FINAL
COUNTY ROAD 3 SHARED USE PATH
BICYCLE/PEDESTRIAN FEASIBILITY STUDY

TOWN OF PIERSON, FL

FEBRUARY 2016

Appendix D - Comments and Responses

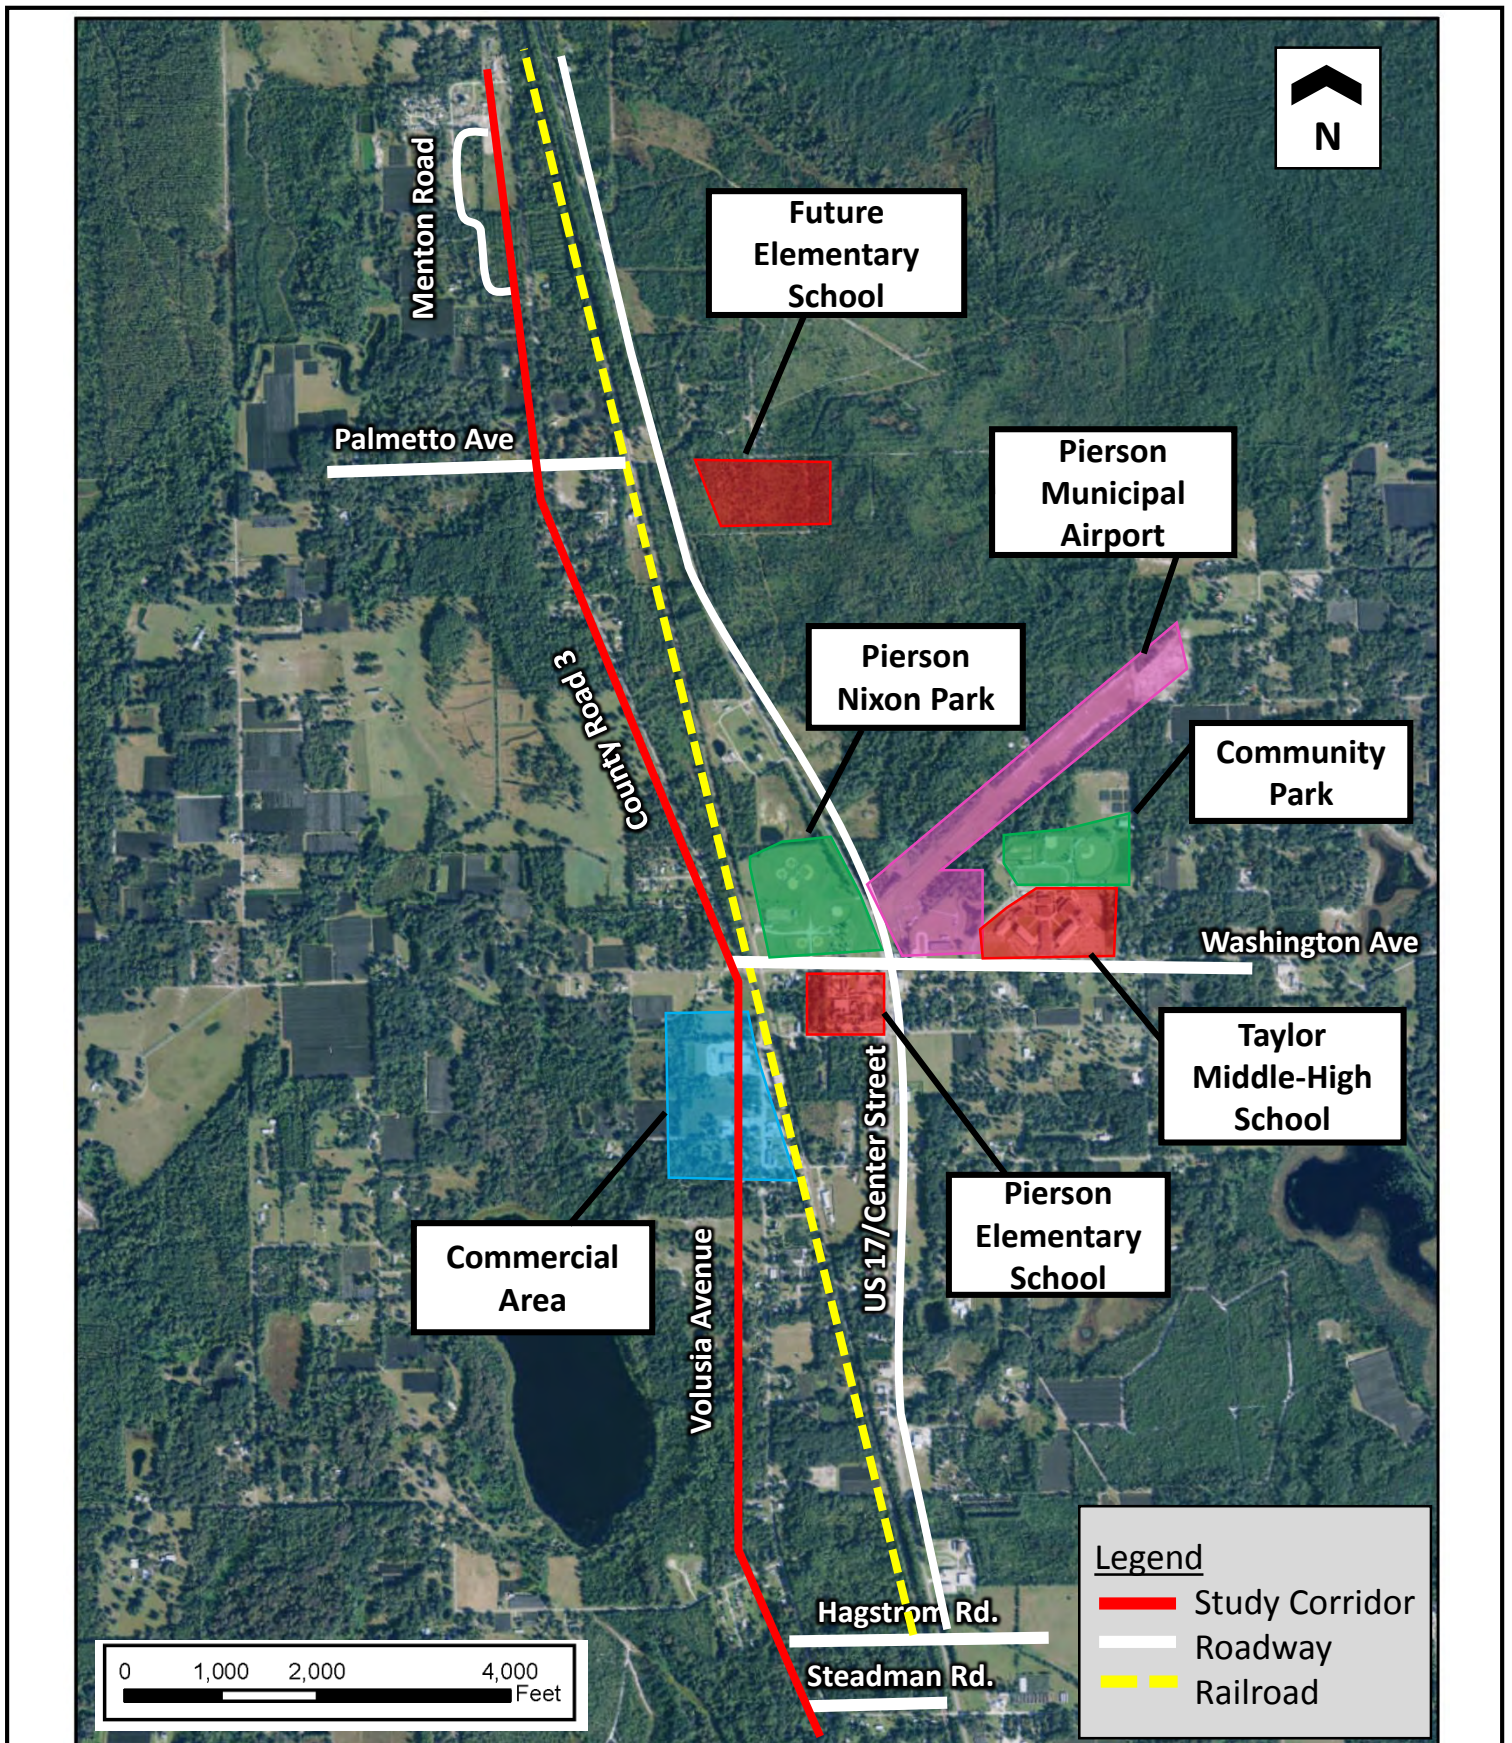
COMMENT	RESPONSE
Figure 2 - Add a scale.	A scale has been added as requested.
Page 11 - Clarify how alignment of trail is affected by these obstacles	Additional discussion has been added to this section.
Page 18 - Provide more detail on your recommendations to resolve drainage issues at CR 3 and Washington Avenue intersection	Additional discussion has been added to this section.
Page 28 - The justification for narrowing the trail to an 8' sidewalk is inadequate. Maintain a 10' to 12' wide trail from 3rd Ave. to Washington Ave.	The conceptual plans have been updated to include a 12 foot trail along the project limits.
Page 28 - Provide justification why the proposed trail is not 12' wide.	The trail has been updated to be 12 feet standard.
Page 29 & 30. Remove the 2020 projection.	We have removed the 2020 projection from the table and text as requested.
Concept Plans - Add Trail symbol to legend, symbolize sidewalk in another color and add to legend.	The symbols have been added as requested.

4A

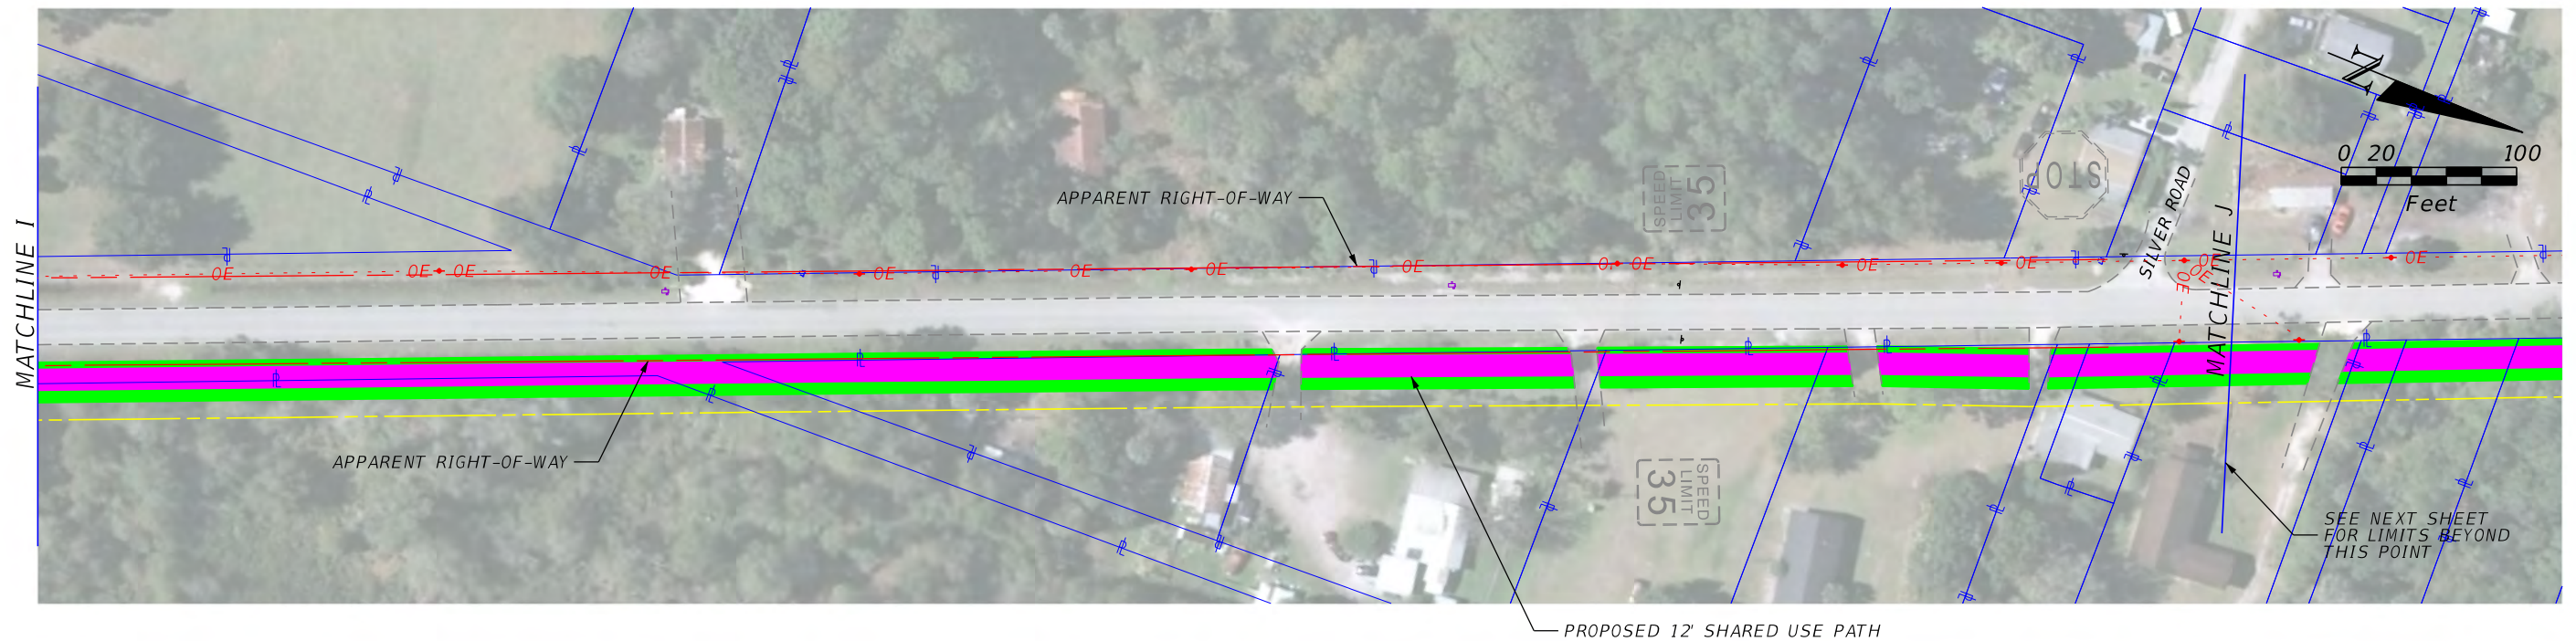
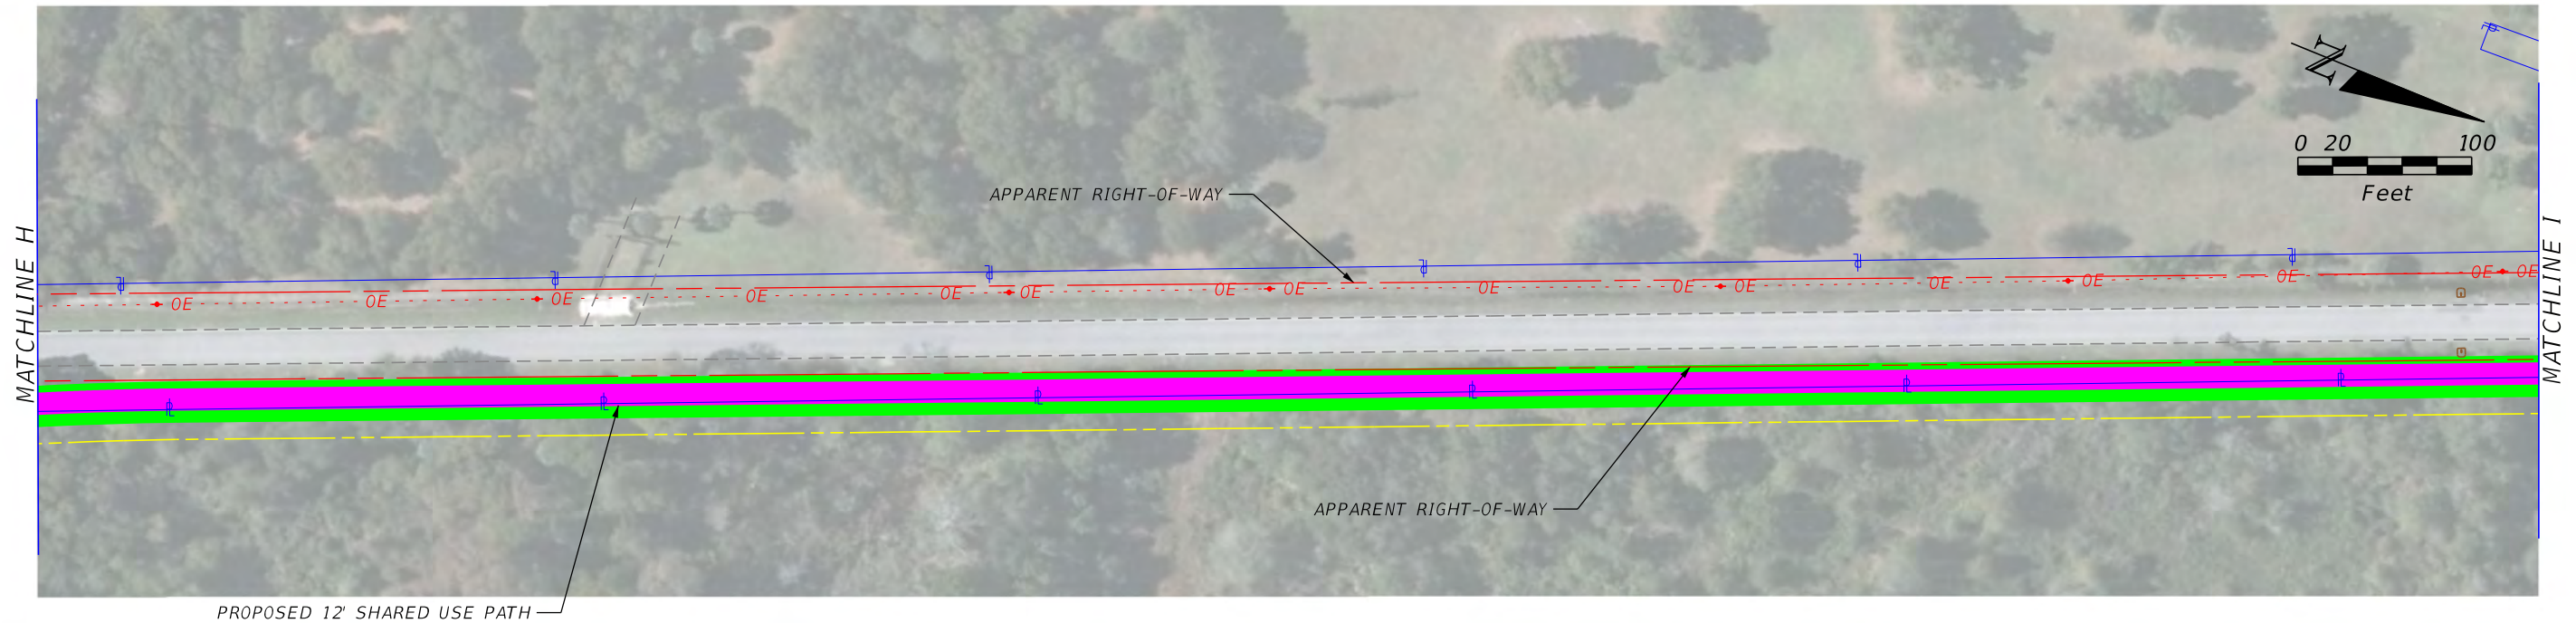
9. CONCEPT PLANS PG 4A:	
a. Will the sidewalk located on the SW corner of Washington Ave and CR 3 require ditch work and additional drainage structures? Was this included in the cost estimate?	Modifications will be required at this intersection. These intersection drainage improvements were included in the cost estimate.

SECTION 6
SILVER ROAD TO SOUTH MENTON

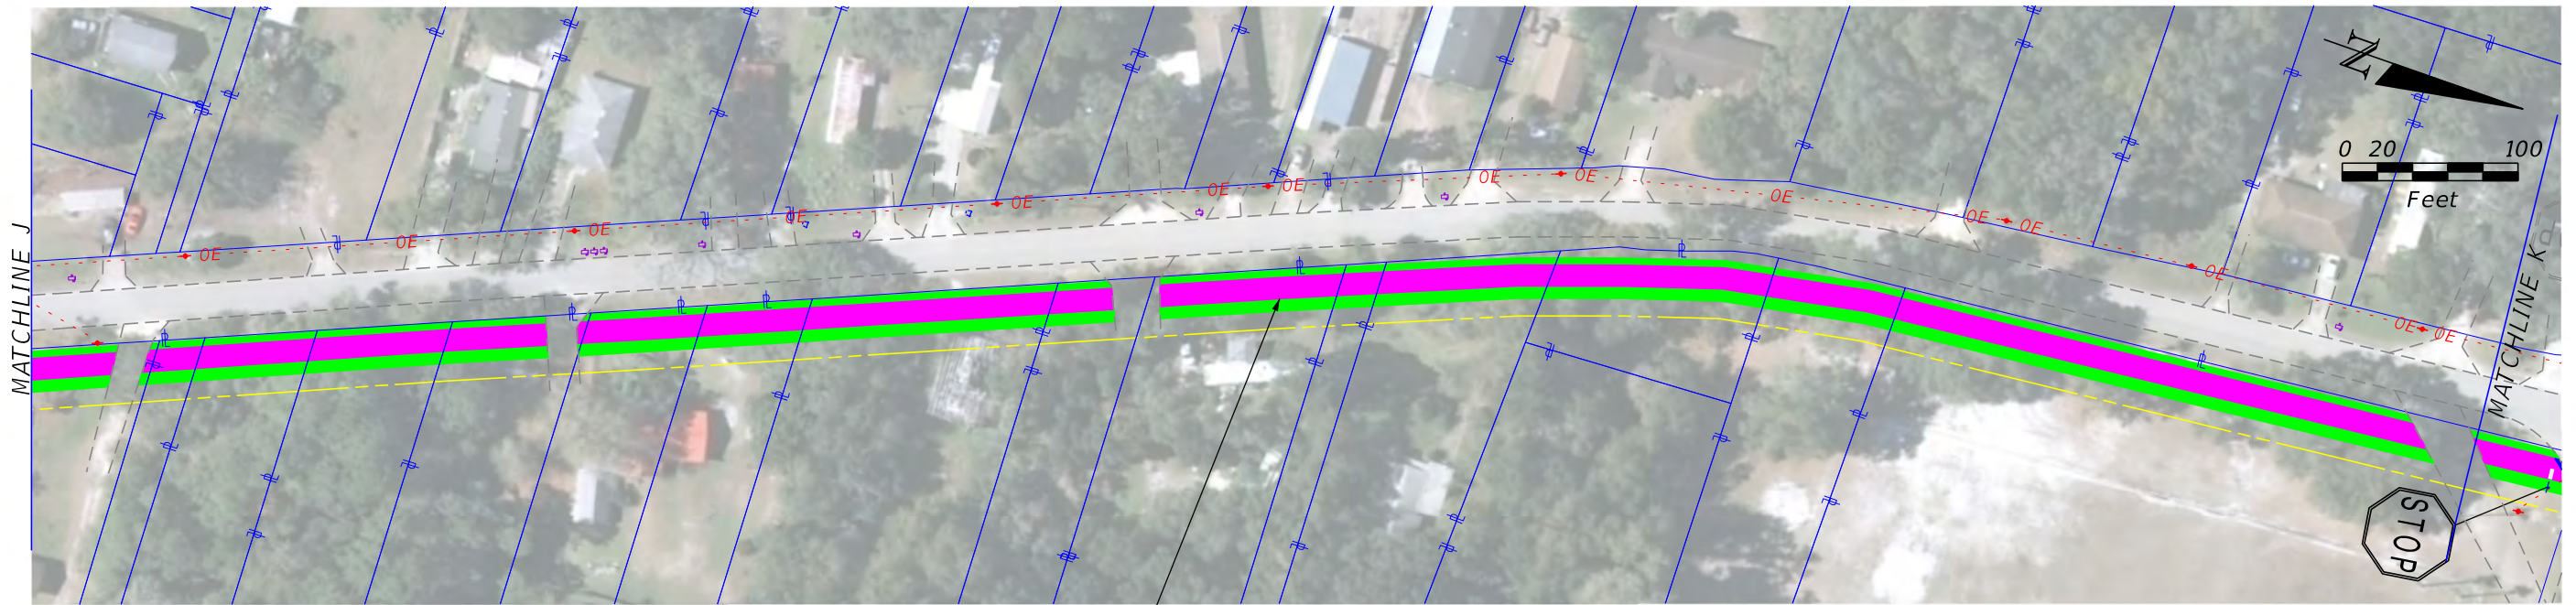
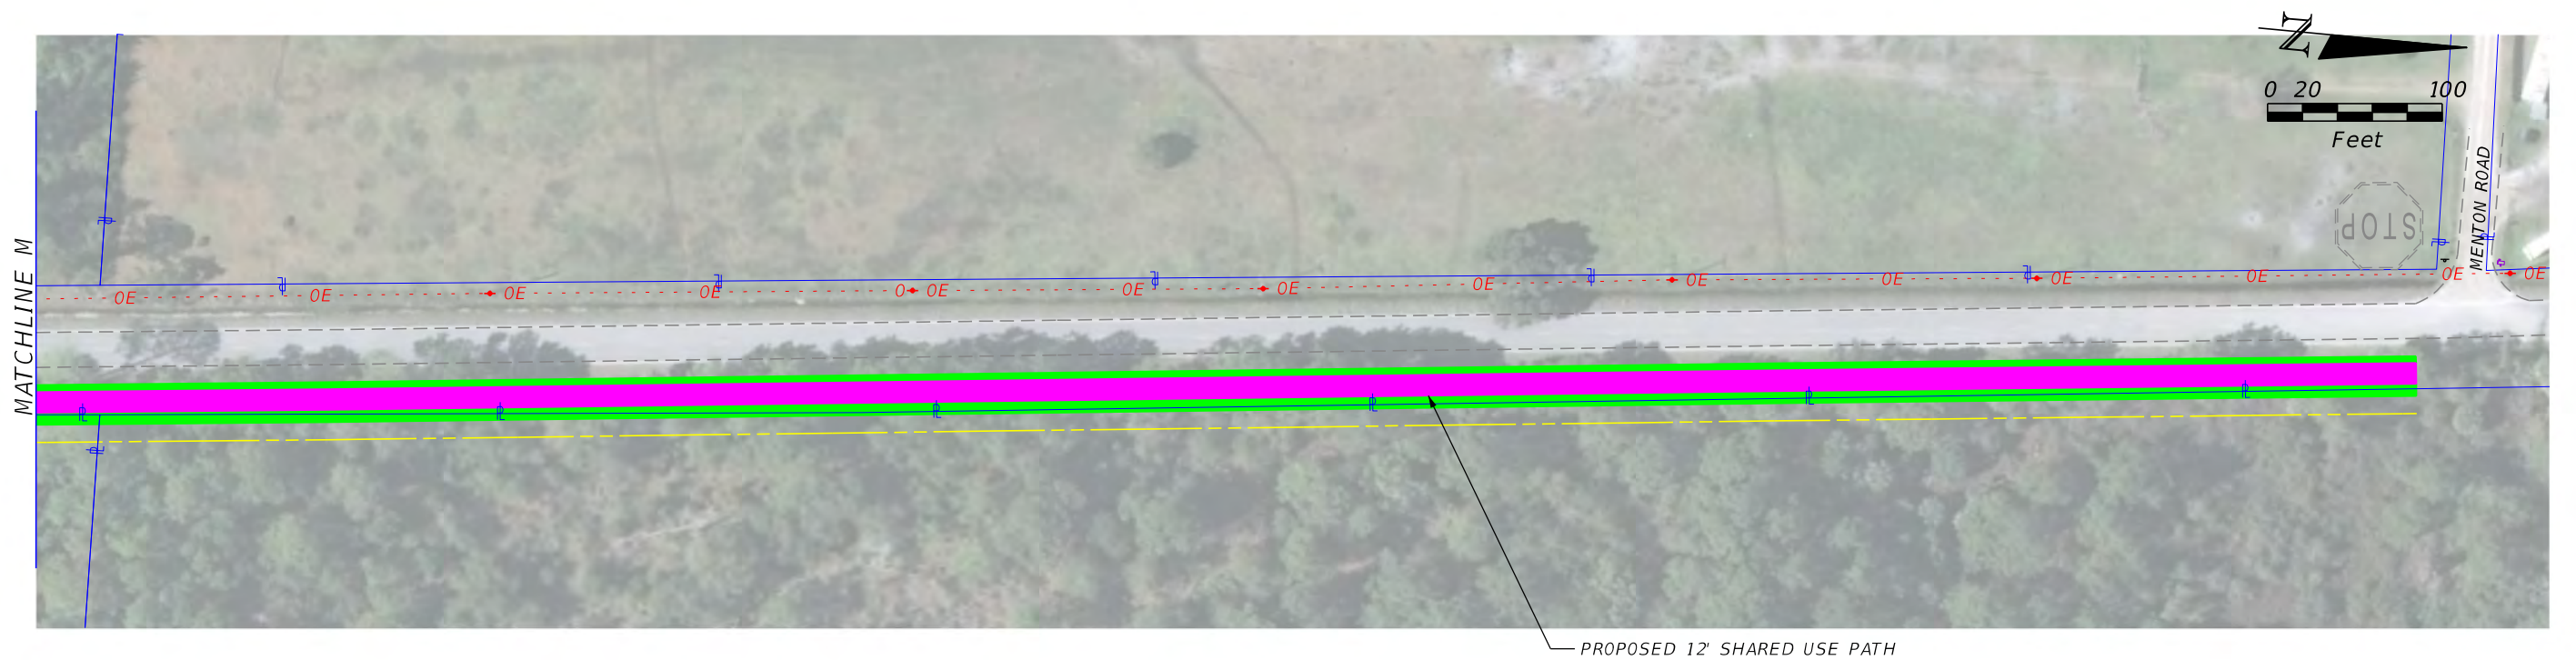
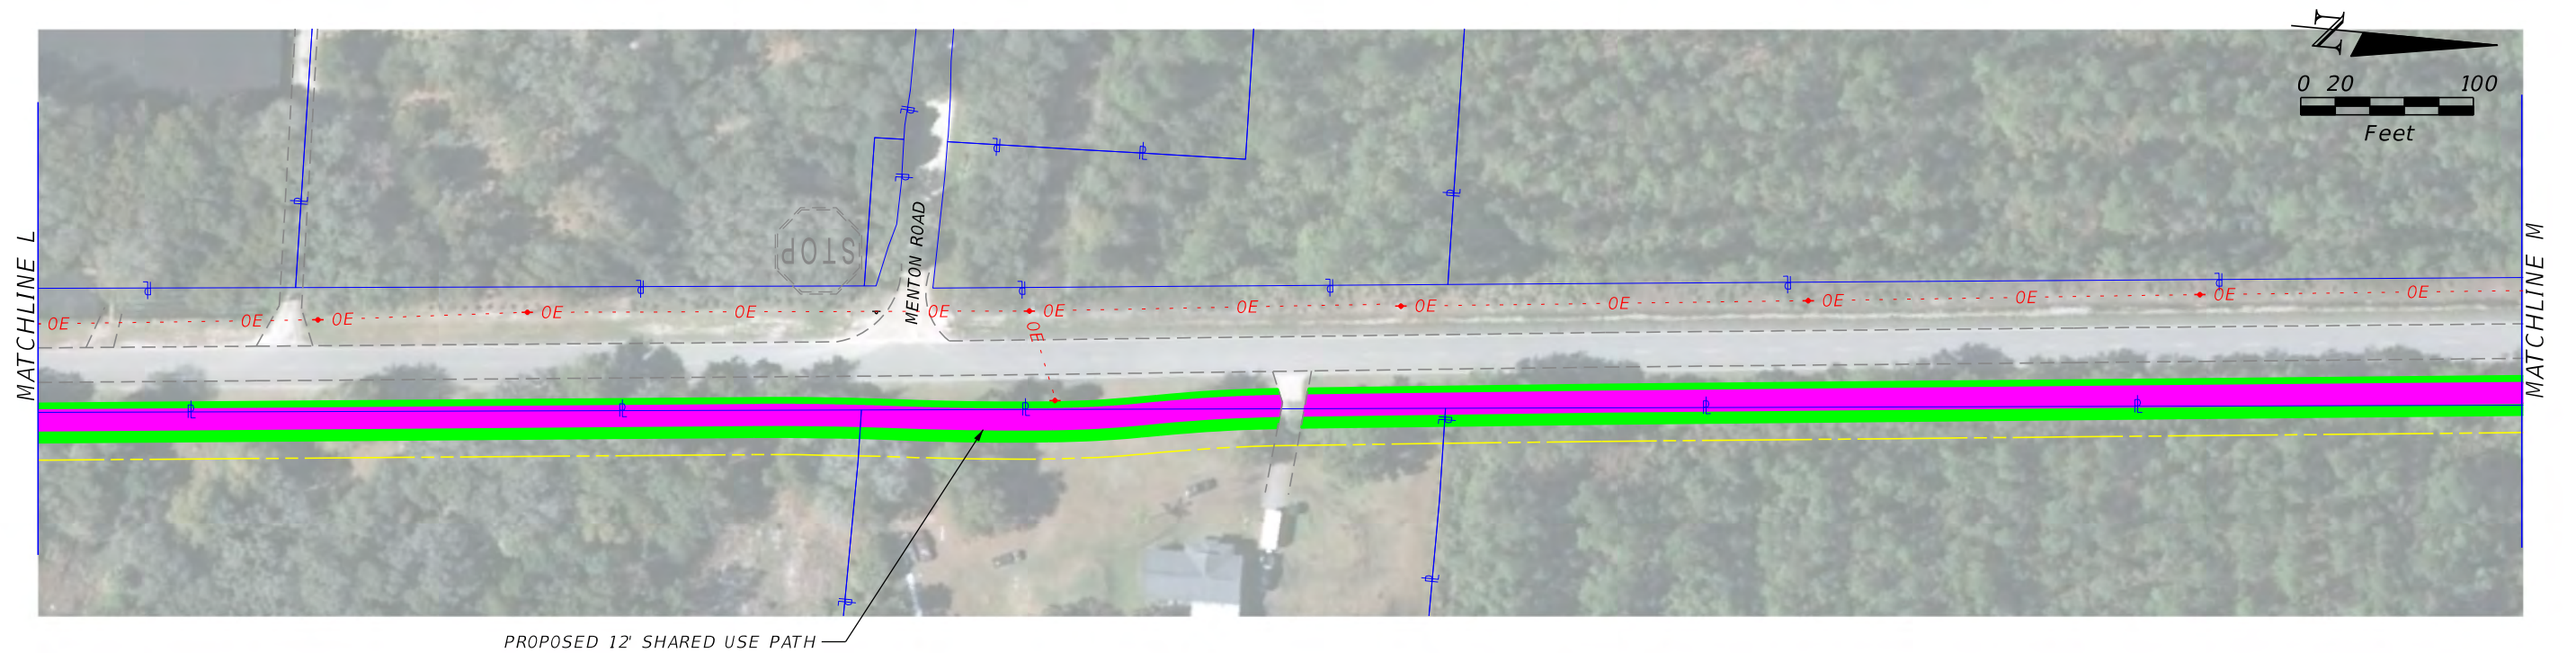
10. CONCEPT PLANS PG 6:	
a. ADA ramps and crosswalk are not shown at Palmetto Ave crossing. Will they be proposed at this intersection? Was this included in the cost estimate?	Updated crossings have been included at all named streets. The cost estimate has also been updated to reflect this.
